**Berkeley Public Library  
Board of Library Trustees**

**Special Meeting  
February 6, 2010**

<b>II. WORKSHOP SESSION ON MEASURE FF WEST BRANCH LIBRARY UPDATE</b>
--

**A. Presentation by Harley Ellis Devereaux/GreenWorks Studio on the Conceptual Design Phase; and Staff Report on the Process, Community Input and Next Steps.**

## REHABILITATION TWO-STORY

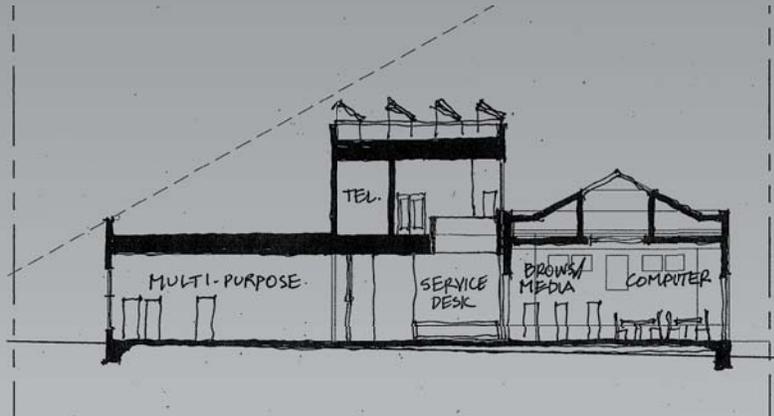
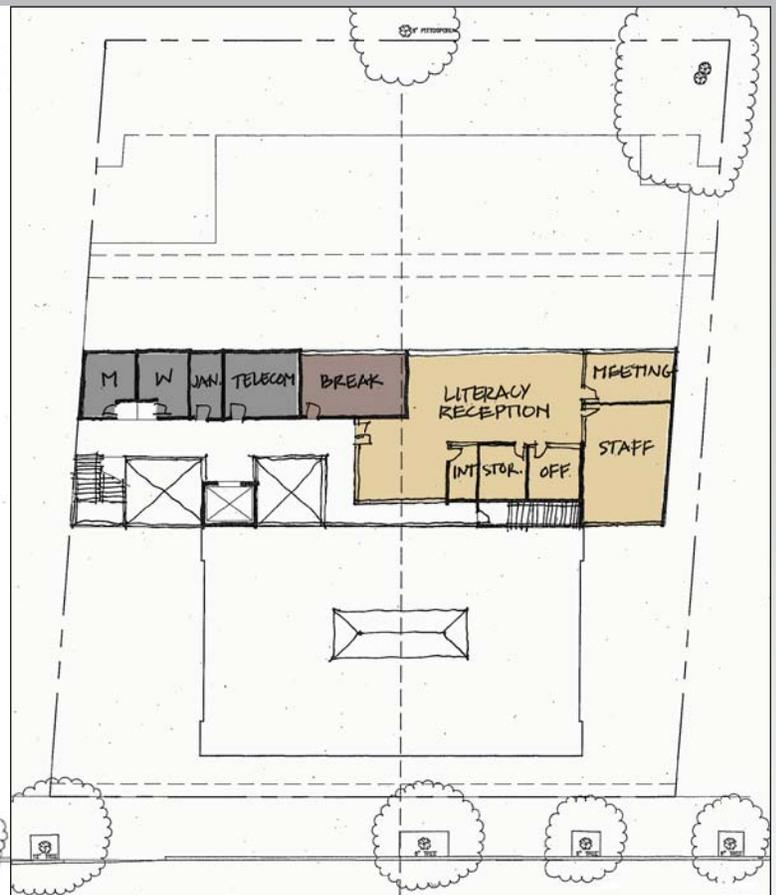
- Retain 1923 building and restores / rebuilds, keep 3-sides of building
- Move building 13 feet closer to street and 18” lower, reducing civic presence

- Create side entrance - reduces traffic noise that would flow into the building; works better for after hour community meeting room access. Original door becomes a window, creating quieter reading room, but disturbing can no longer use original entry after remodel (not currently in use as entry).

- Scheme layout meets the building program provided. Shortfalls include: book drop detached from staff work room /return sorting area and could not accommodate automated material handling system in future. Fair job of respecting the building and fair to good job of meeting library needs.

- Would require removal of one redwood tree in the back left where corner of building would go.
- Traffic noise study found original entry would create unacceptable noise levels (70 dbA average) in the library reading space if it were operable, front wall protects the interior reading area now, not accounted for in master plan or earlier study.

- Relocates and Lowers 1923 Building
- Major Reconstruction Required
- 1923 Main Entry Closed Off
- Inefficient Floor Plan
- Book Drop Detached from Returns
- Less Effective Daylighting
- Less Roof Area for Photovoltaics
- Three Redwood Trees Removed

## NEW CONSTRUCTION ONE-STORY

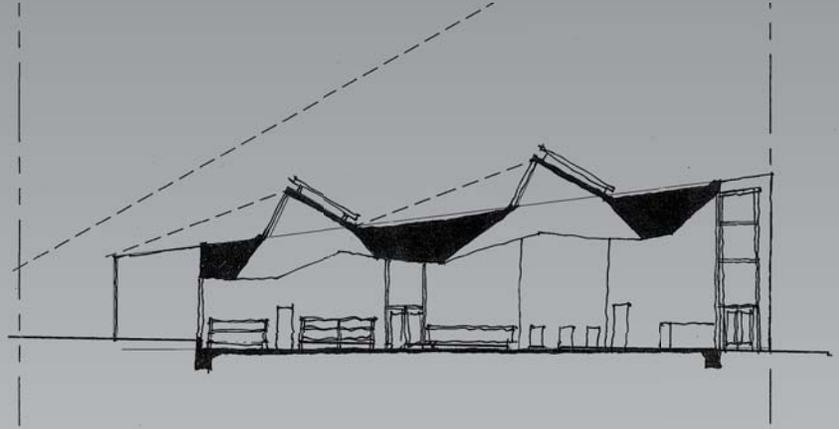
- Float roof up to meet solar access requirements
- Raise building at street to create civic presence and loft like space
- Saw tooth monitors on roof with windows on north side and photovoltaic panels on south side to provide daylight to the interior needed during daytime.
- Conflicting goals of displaying activities inside and distraction of street/traffic activity– large window introduced.
- Flexible spaces with new construction - could change purposes later if library needs to change.
- Maximizes site space, less landscaping.
- Lower at rear due to slope, retaining walls in rear.
- Allows for direct access to the sidewalk level.

New one-story (Scheme B) is most efficient, all on one floor, don't need elevator or stairs. It fills the site resulting in less outdoor space. Most efficient, least extra gross SF because no need for elevator or stairs and meets the program. No space to expand footprint.

- Removes 1923 Building
- Minimal Outdoor Space

## NEW CONSTRUCTION TWO-STORY

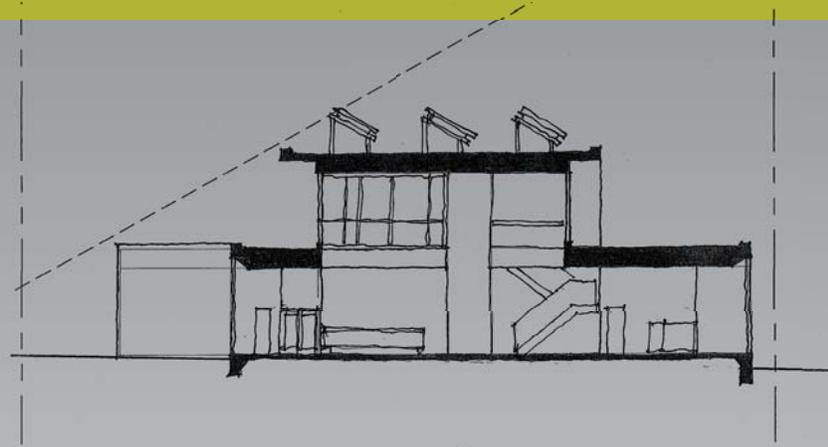
- More exterior space – more generous garden
- Less potential for shading on photovoltaic systems than Scheme B.
- Existing redwood trees maintained and visible from the street.
- Entrance door faces east, slightly above street level, slope up so slightly raised.
- Central atrium brings in light to interior
- Literacy on 2<sup>nd</sup> floor own space – could add roof terrace,

- 8) Trustee Kupfer asked for more on the compromised sightlines and adjacencies in scheme C. *Sightline from service desk to adult room is minimally compromised by elevator shaft.*

*Ms Wallis explained the problem was constraint on sides, code does not allow windows on the lot line due to fire rating restrictions, so very little lighting coming in from the side. Second floor removes possibility for skylights in the area below the second floor (only). Architects believe they can mitigate this for the most part, some zones more challenging than others. Atrium walls will have glazing up high to bring in daylight. Staff workroom would be impacted the most, could use "light tubes" to bring in daylight to this area.*

- Sightlines & Adjacencies Comprised by Vertical Circulation
- Less Effective Daylighting
